City of Albuquerque

RE: GRADING/PAVING PLAN FOR MOUNTAIN BELL @ 2327 ALAMO, SE
(M-16/D3A) REVISION DATE OF AUGUST 26, 1988

RE: DRAINAGE PLAN FOR MOUNTAIN BELL @ 2327 ALAMO, SE
(M-16/D3A) RECEIVED AUGUST 9, 1988

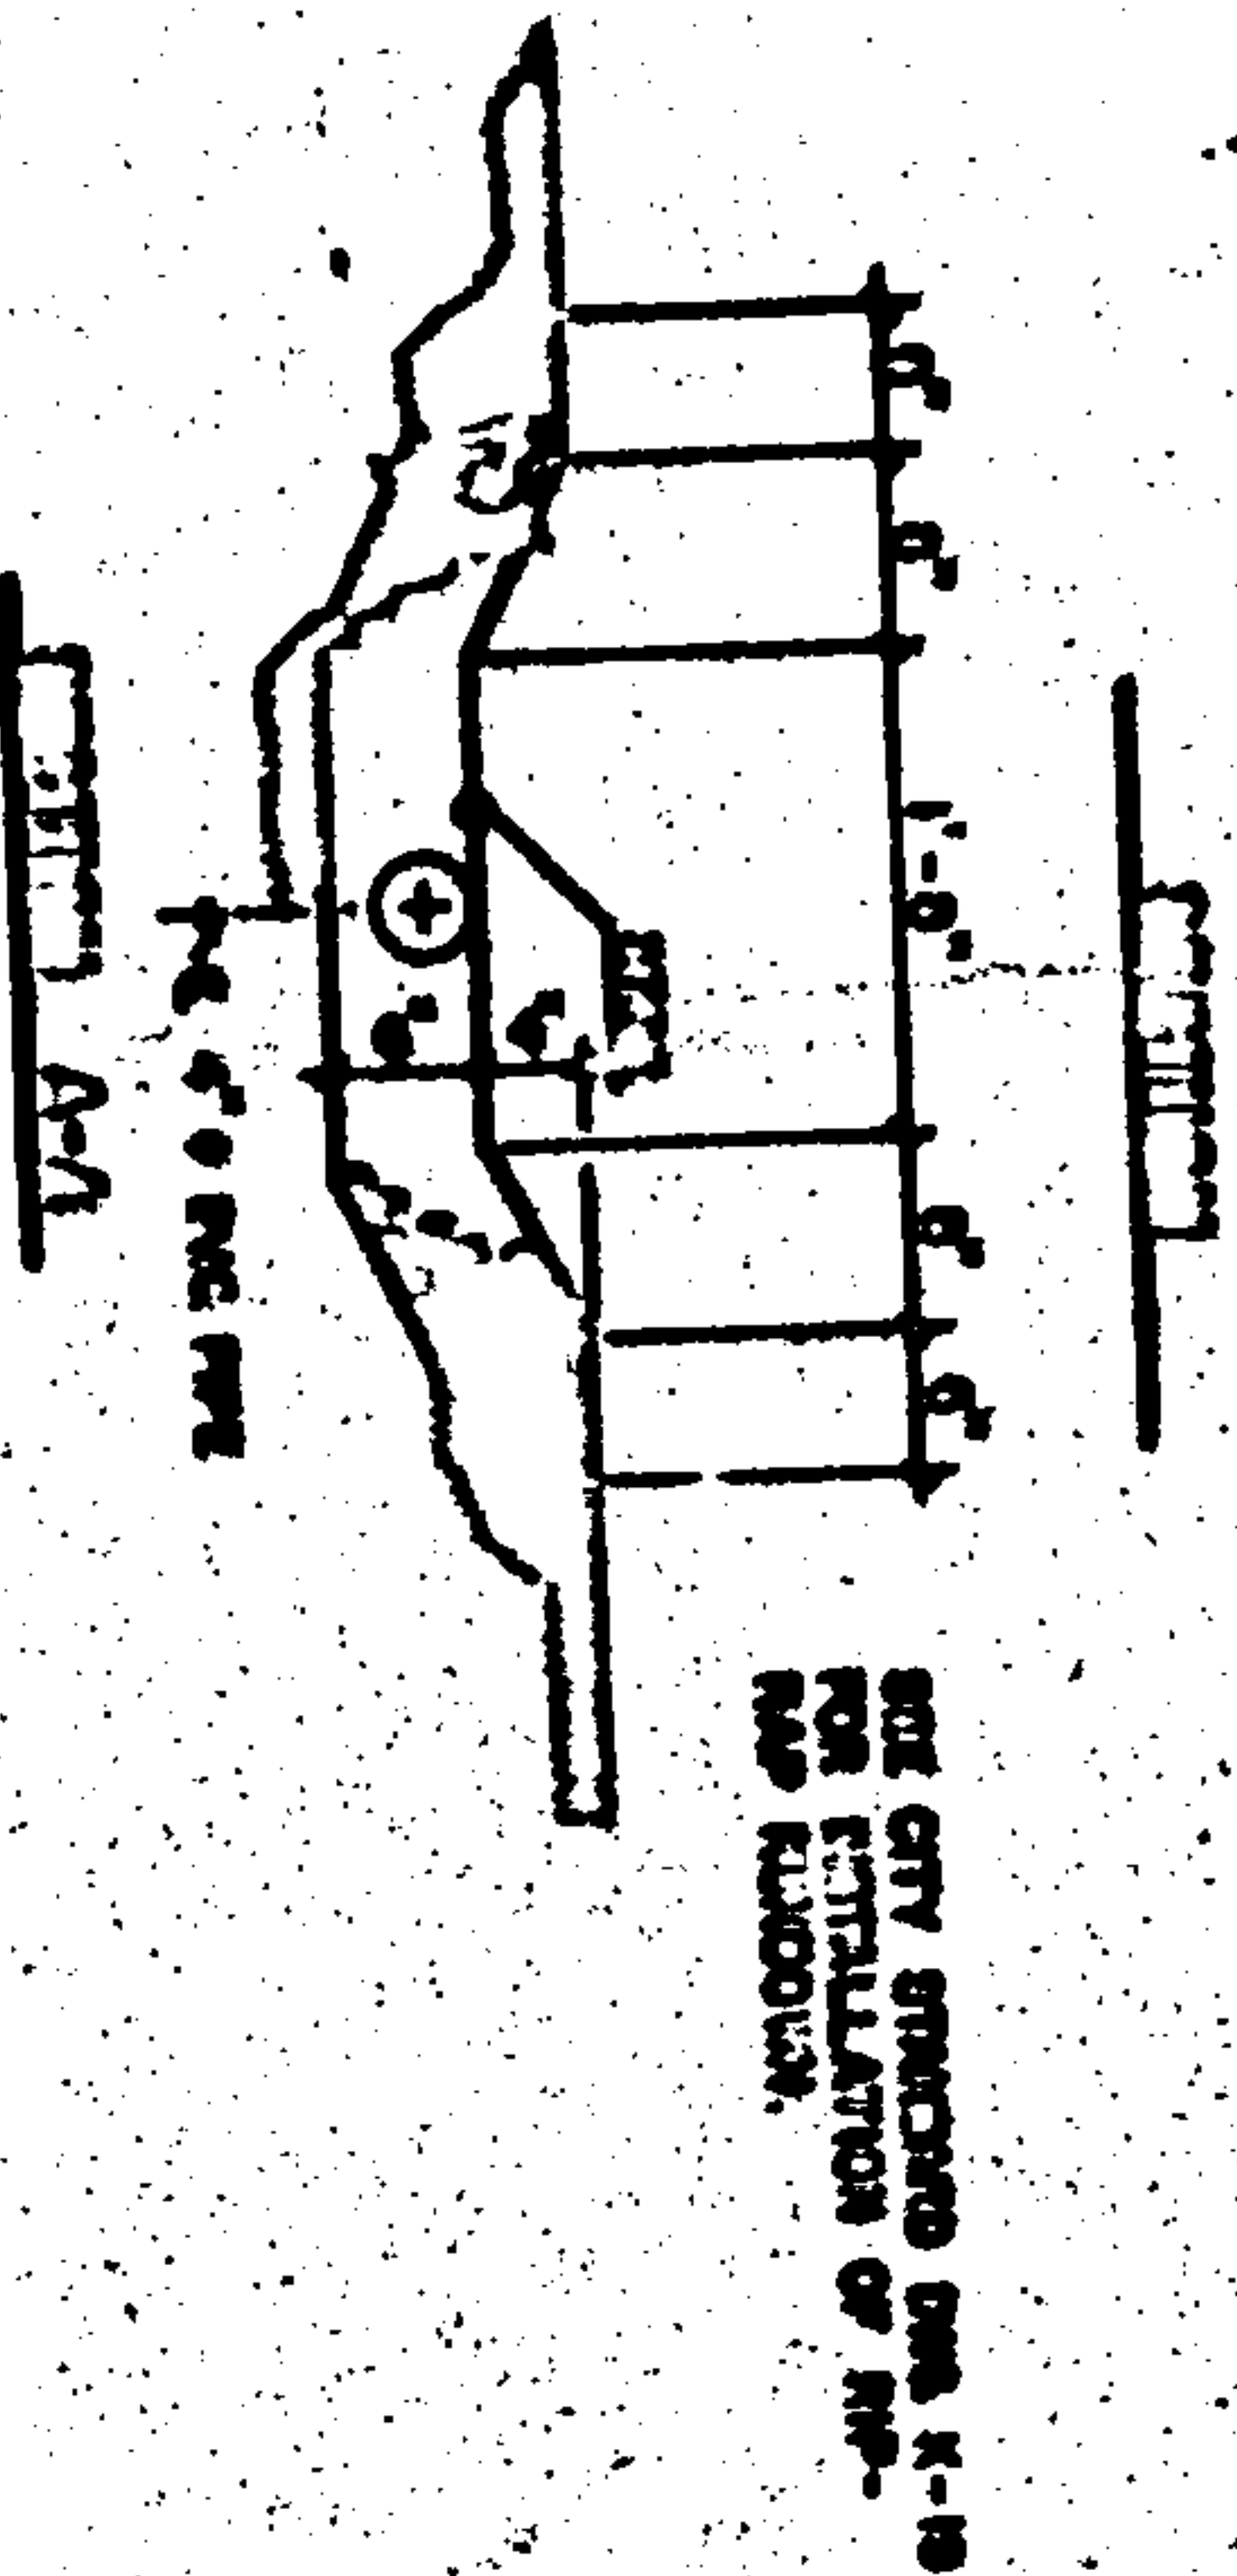
Based on the information provided on your resubmittal listed are four items that will need to be addressed prior to approval.

1. Quantification of offsite rate of flow caused by the contributing watershed. You must accept the offsite flows from the existing undeveloped site to the east.
2. Once the offsite flows enter the site, how do you propose to handle them.
3. We will need an easement or replat for cross lot line drainage. Even if the properties are owned by the same owner, we will need something that will run with the land.
4. What type of compaction specifications do you propose for the earth berm.
